## Joystick Piloting for Outboard (JPO) Vessel Upgrade

NOTICE
Revised May 2018. This bulletin supersedes the previous bulletin number 2017-08 November 2017.
The bulletin includes revisions to the following procedures:
<ul style="list-style-type: none"> <li>System Checklist</li> </ul>

Green color paint dot

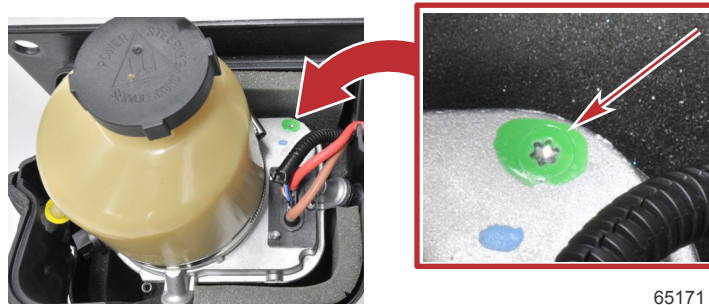
1. Remove the cover of the power steering pump.
2. Inspect the pump motor body for a green color paint dot. This dot will be located aft of the wire harness exiting the pump motor body. Refer to the following picture.

3. If the power steering pump body is not marked with a green color paint dot, a new power steering pump assembly must be ordered, installed, and the system purged of air. Refer to the appropriate service manual or installation manual on how to purge the power steering system of air.

Step locations—steering cylinder

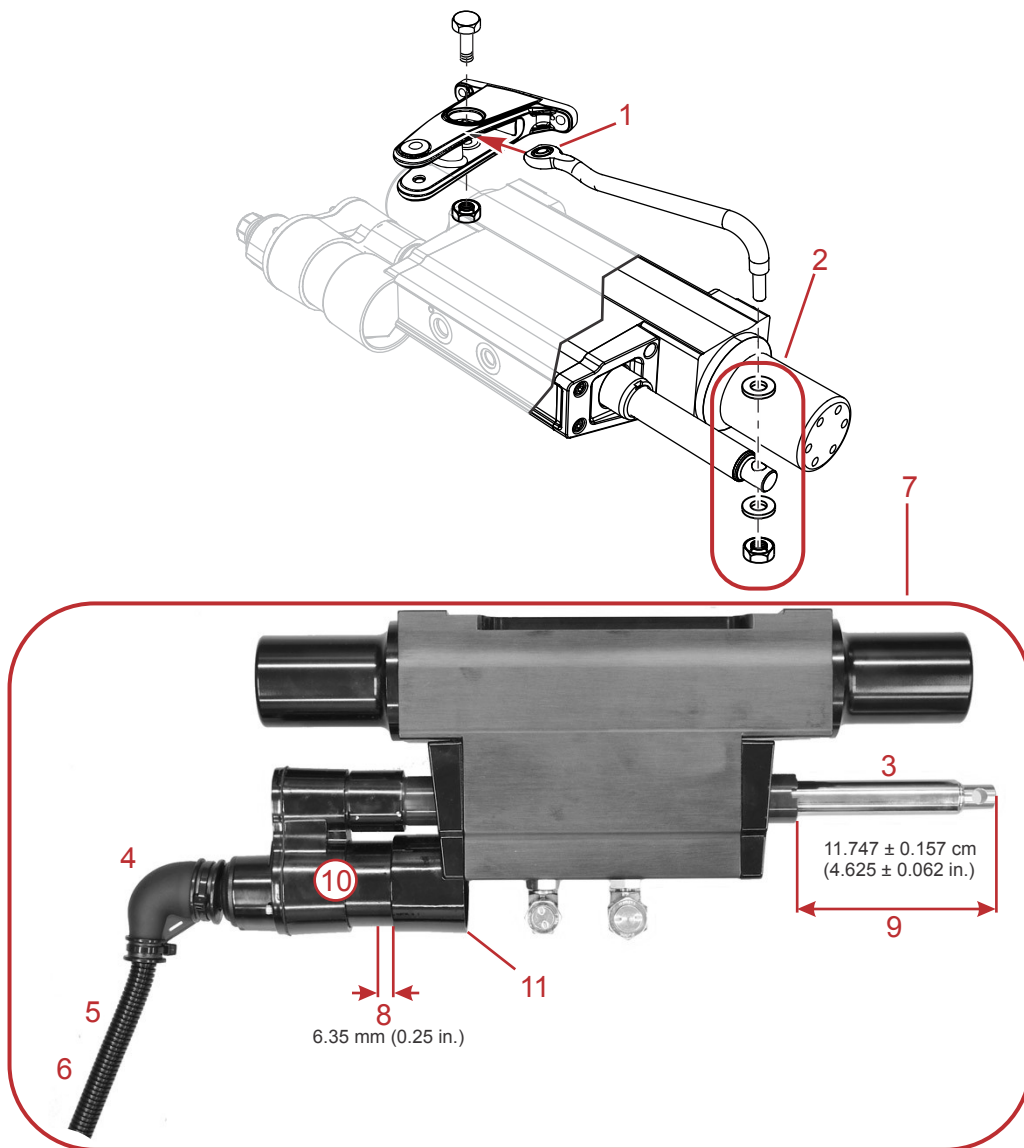
Refer to the following graphic illustration to identify the step locations.

Step	Check	Notes/Action Items	Complete
1	Link rod between actuator extension tube and tie bar arm can be rocked fore and aft	Apply 2-4-C with PTFE to the link rod extension arm ball joint at the tie bar arm.	
2	Steering cylinder link rod nut is properly tightened	Top and bottom washers should spin freely. Tighten the nut to 13.5 Nm (120 lb-in.) then back off 1/4 turn.	
3	No grease in the steering cylinder extension tube	Clean with mild solvent spray if grease is found. Apply engine oil to the steering cylinder.	
4	Steering cylinder plastic 90° elbow is installed correctly—secured to the actuator with cable ties	If elbow is missing, order and install elbow.	
5	Steering cylinder 6-pin electrical harness on transom is loose and not restrained within 15.3 cm (6 in.) of the cylinder	If the harness is too tight, it will restrict movement which will lead to little or no hydraulic assist and cause steering follow faults.

6	Steering cylinder 6-pin electrical harness is routed below the anticollision cable	If routed above, disconnect anticollision cable and route the electrical cable below.	
7	Steering cylinder assembly is not obstructed	Turn steering wheel lock-to-lock; ensure no interference or contact with other components or the bulkhead.	
8	Steering cylinder motor has unobstructed movement near antirotation bracket (item 11 in illustration)	<p>With the engine running, rotate the steering wheel rapidly 1/4 turn back and forth while watching the electric motor of the steering cylinder near the antirotation bracket: electric motor should move approximately 6.35 mm (0.25 in.) total.</p> <p><b>NOTE:</b> G3 JPO steering system bleed test can be utilized for 250 hp and 300 hp (2B144123 and up) and all 350 hp and 400R hp engines.</p>

Step locations—steering cylinder

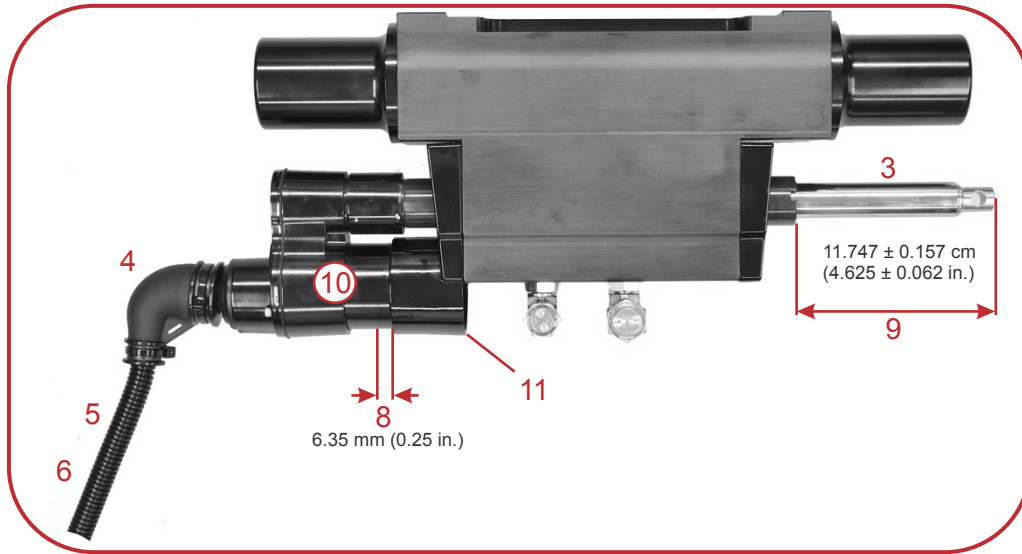
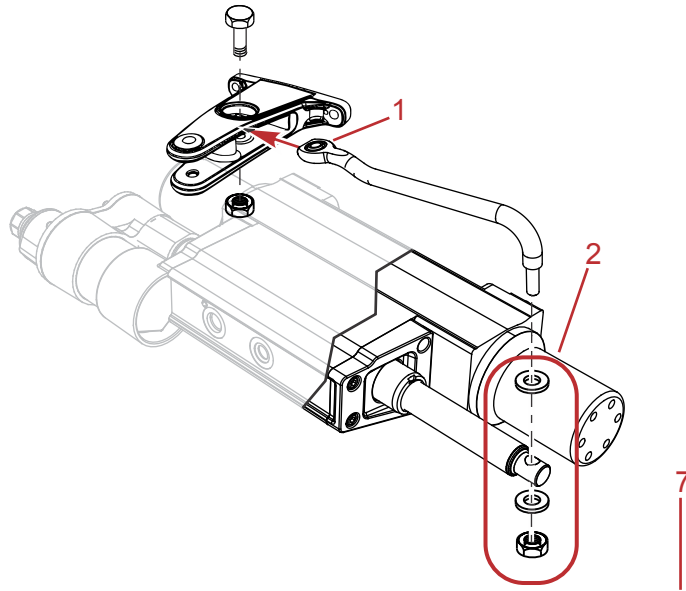
Refer to the following graphic illustration to identify the step locations.

Step	Check	Notes/Action Items	Complete
1	Link rod between actuator extension tube and tie bar arm can be rocked fore and aft	Apply 2-4-C with PTFE to the link rod extension arm ball joint at the tie bar arm.	
2	Steering cylinder link rod nut is properly tightened	Top and bottom washers should spin freely. Tighten the nut to 13.5 Nm (120 lb-in.) then back off 1/4 turn.	
3	No grease in the steering cylinder extension tube	Clean with mild solvent spray if grease is found. Apply engine oil to the steering cylinder.	
4	Steering cylinder plastic 90° elbow is installed correctly—secured to the actuator with cable ties	If elbow is missing, order and install elbow.	
5	Steering cylinder 6-pin electrical harness on transom is loose and not restrained within 15.3 cm (6 in.) of the cylinder	If the harness is too tight, it will restrict movement which will lead to little or no hydraulic assist and cause steering follow faults.

6	Steering cylinder 6-pin electrical harness is routed below the anticollision cable	If routed above, disconnect anticollision cable and route the electrical cable below.	
7	Steering cylinder assembly is not obstructed	Turn steering wheel lock-to-lock; ensure no interference or contact with other components or the bulkhead.	
8	Steering cylinder motor has unobstructed movement near antirotation bracket (item 11 in illustration)	<p>With the engine running, rotate the steering wheel rapidly 1/4 turn back and forth while watching the electric motor of the steering cylinder near the antirotation bracket: electric motor should move approximately 6.35 mm (0.25 in.) total.</p> <p><b>NOTE:</b> G3 JPO steering system bleed test can be utilized for 250 hp and 300 hp (2B144123 and up) and all 350 hp and 400R hp engines.</p>
